## PROJECT NAME:Farber Building RenovationsPROJECT NUMBER:EN2401

#### ADDENDUM NUMBER: THREE

DATE OF ISSUANCE: January 15, 2025

EXISTING AND DEMOLITION PLAN A-1.01 SCALE: 1/8" = 1'-0"

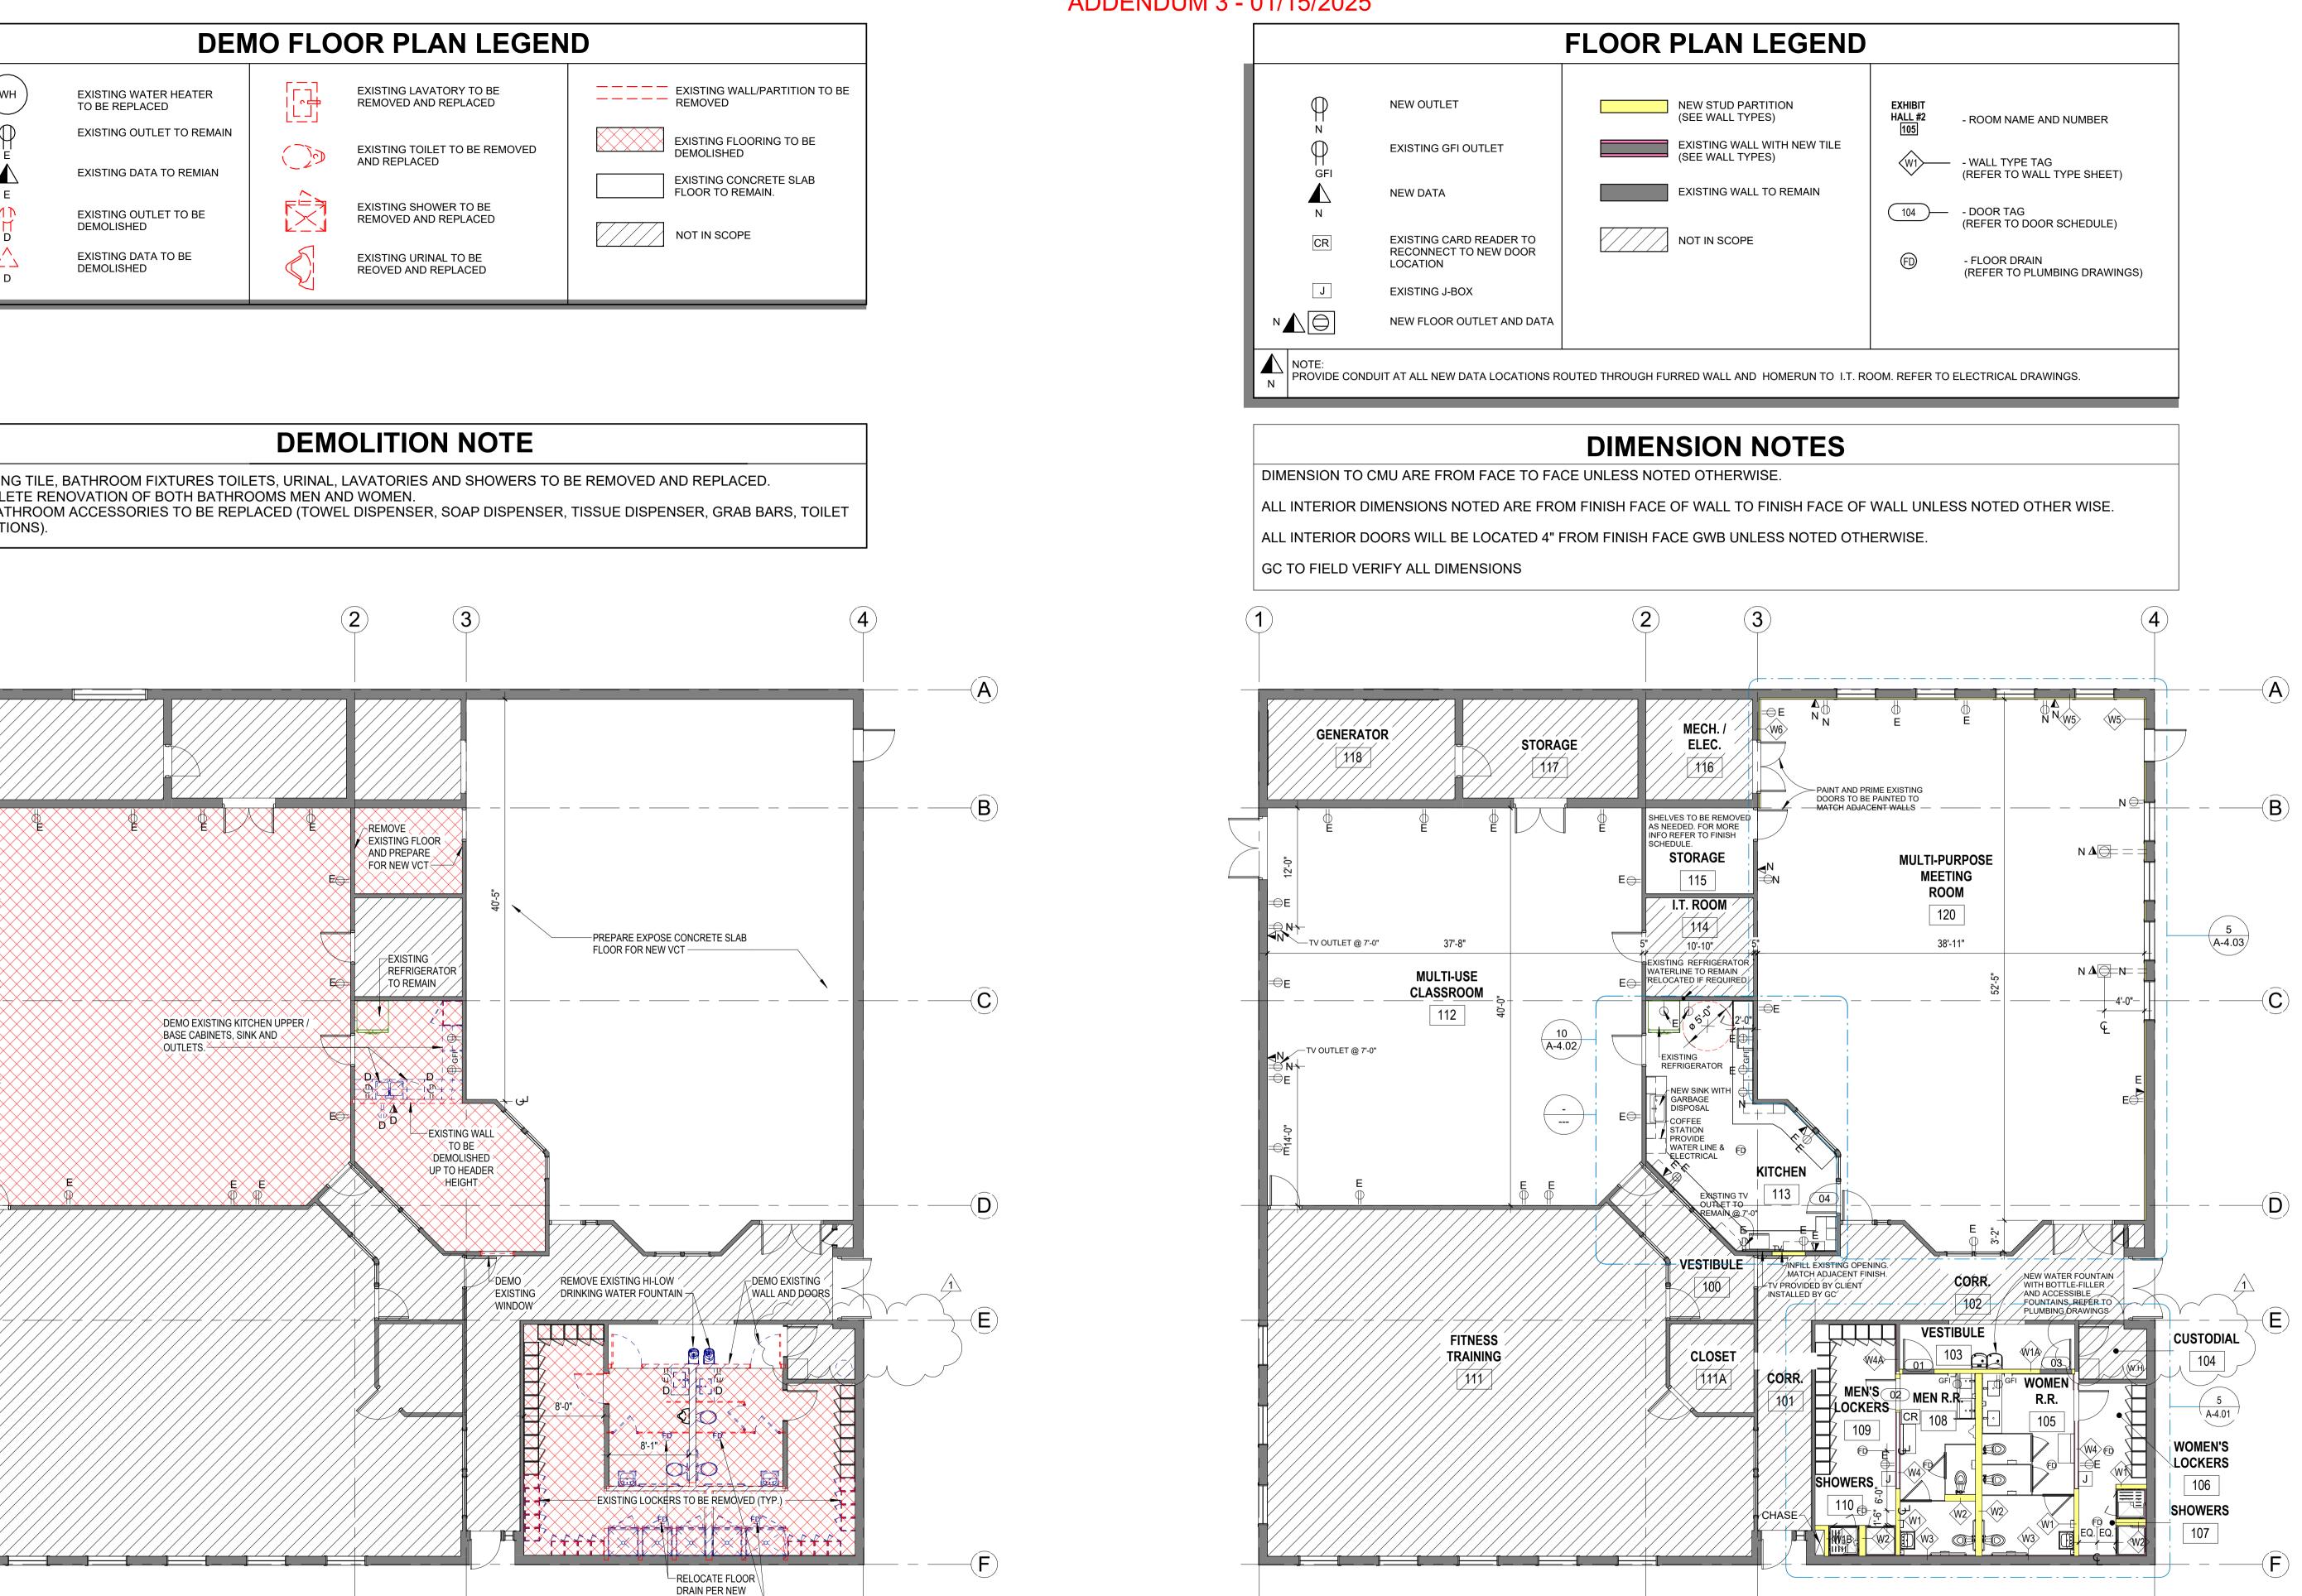
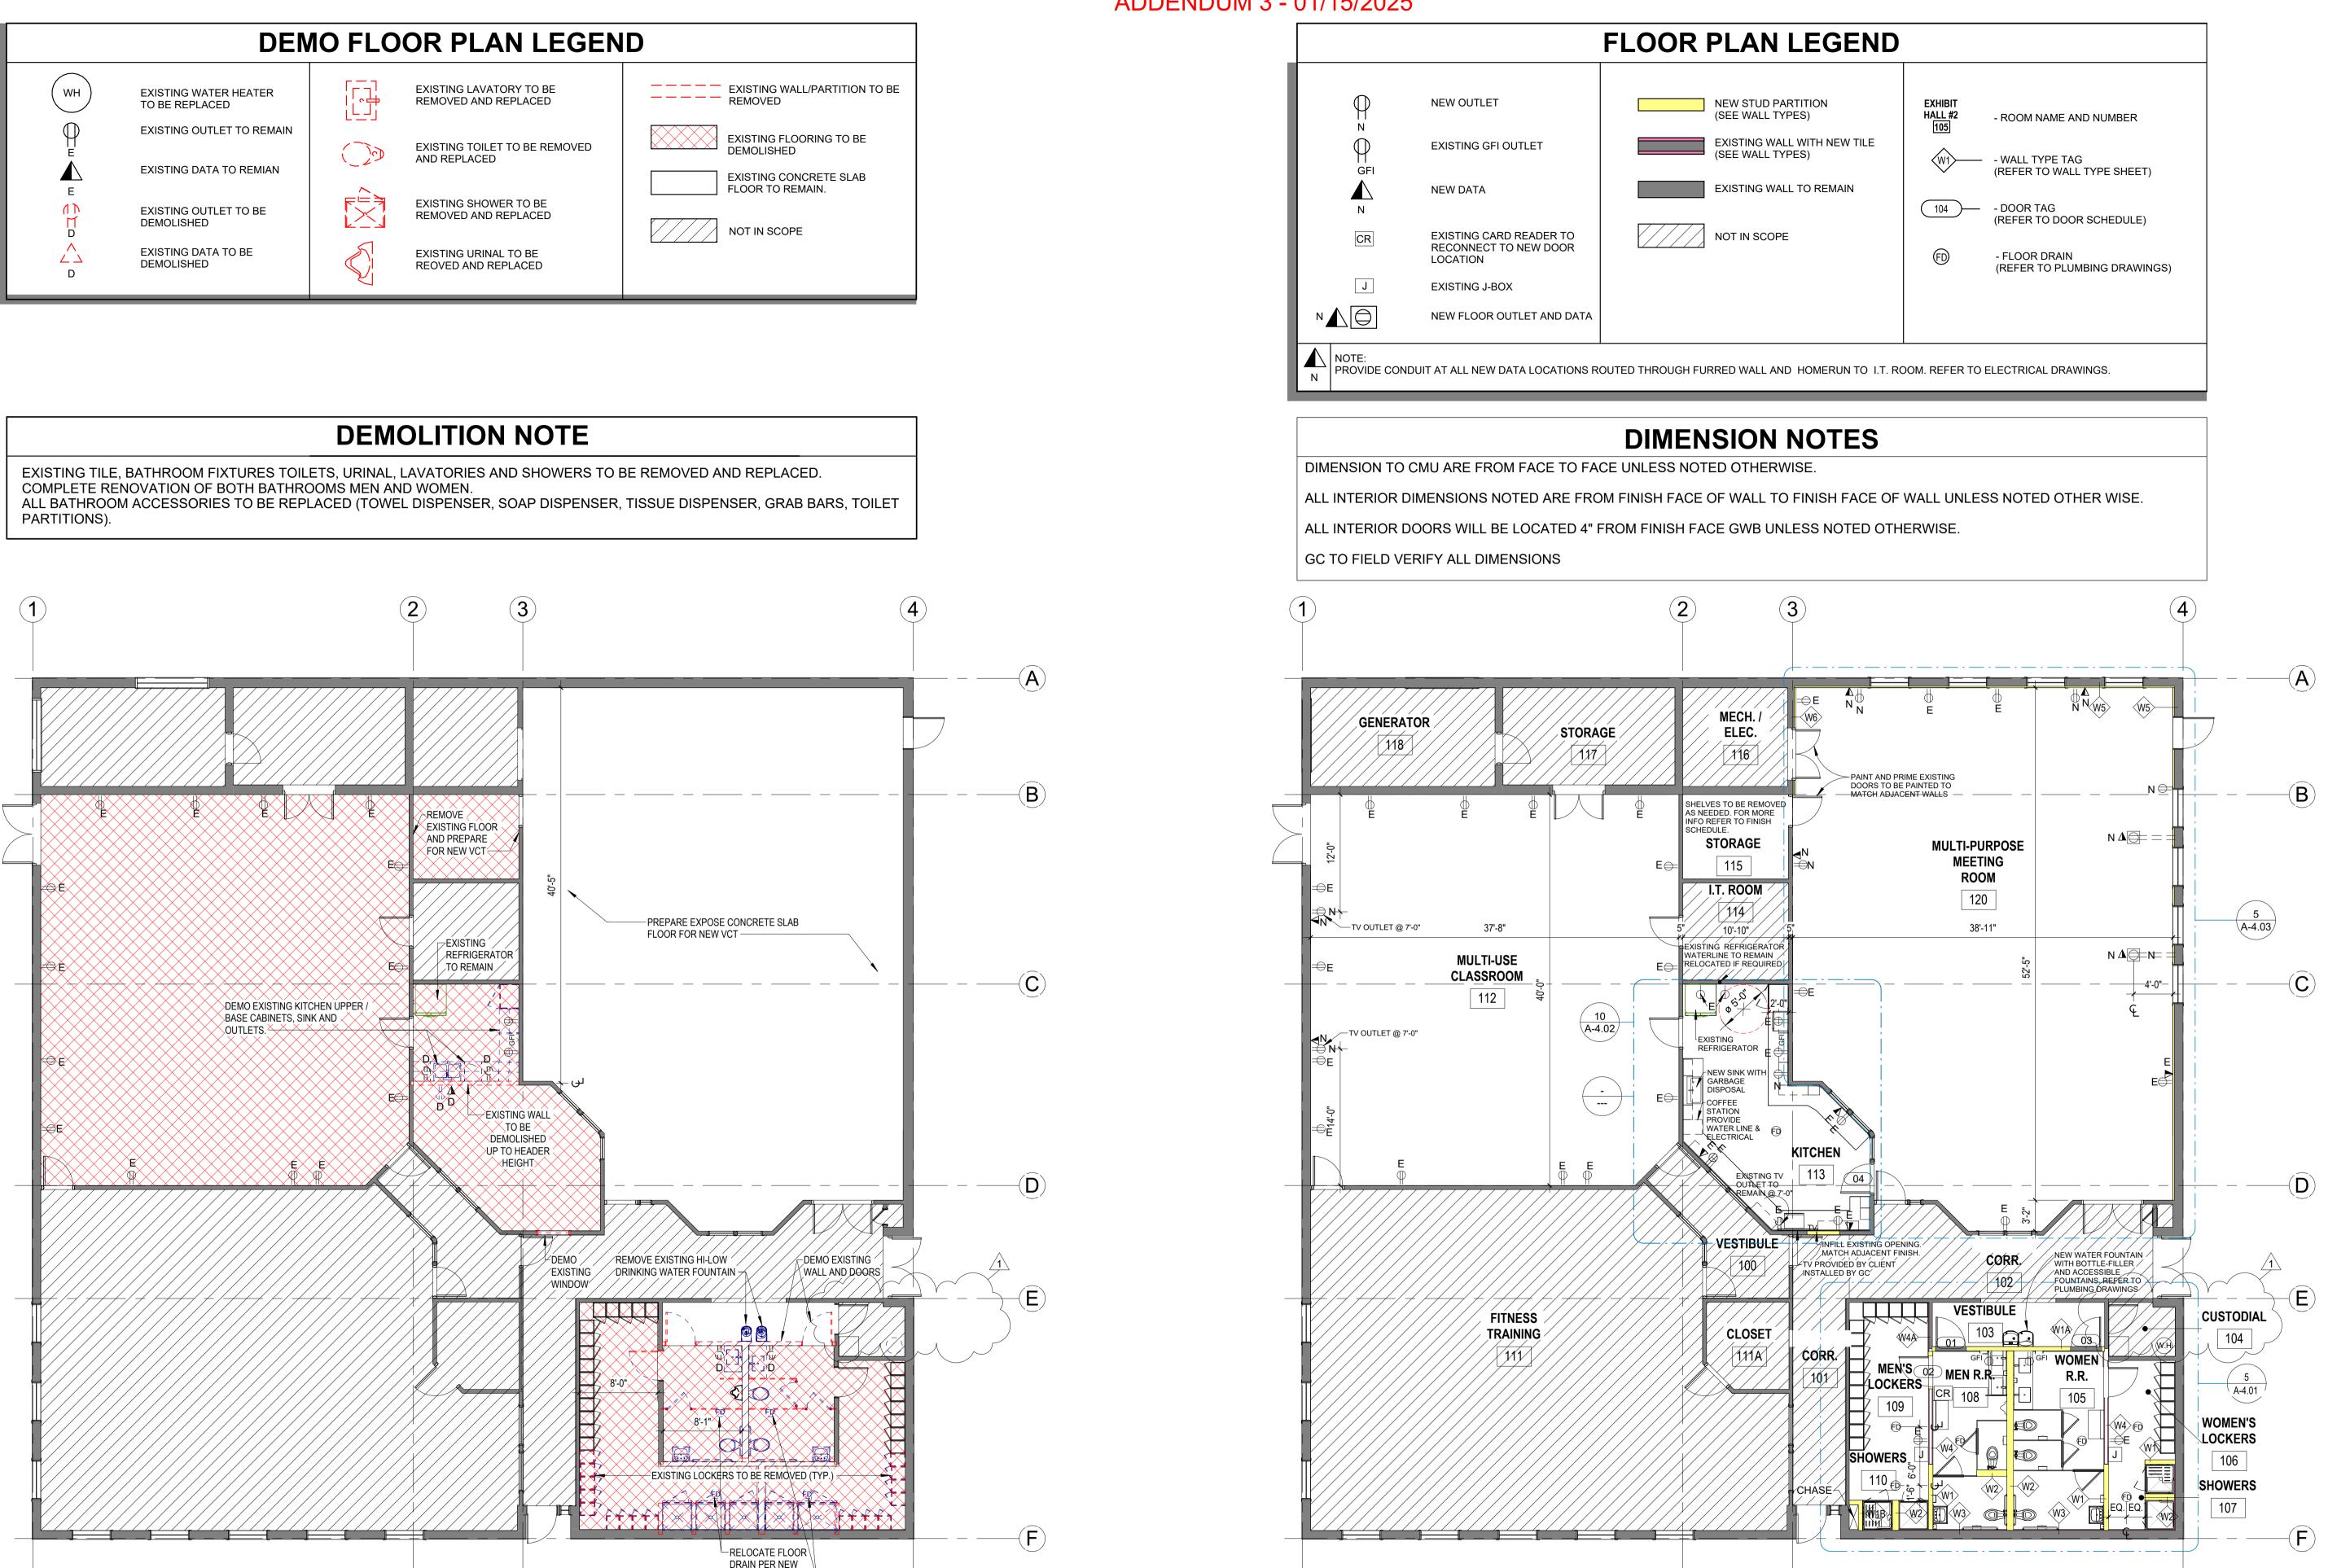
- 1) Bid opening date is changed from Tuesday, January 21, 2025 at 3:00 P.M. to Thursday, January 23, 2025 at 3:00 P.M.
- Bidders shall delete item 1 from Addendum two: The hot water heater noted on A-1.01, A-4.01, and P-1.16 call out shall be changed from remove and replace to existing shall remain
- Bidders shall remove plan sheets A-0.10, A-1.01, A-4.01, A-4.02, A-5.01, A-5.03, F-0.0, F-0.01, FA-1.01, P-1.12, P-1.13, P-1.15, P-1.16, P-2.01 and add revised Addendum three sheets A-0.10, A-1.01, A-4.01, A-4.02, A-5.01, A-5.03, F-0.0, F-0.01, FA-1.01, P-1.12, P-1.13, P-1.15, P-1.16, P-2.01 (attached)
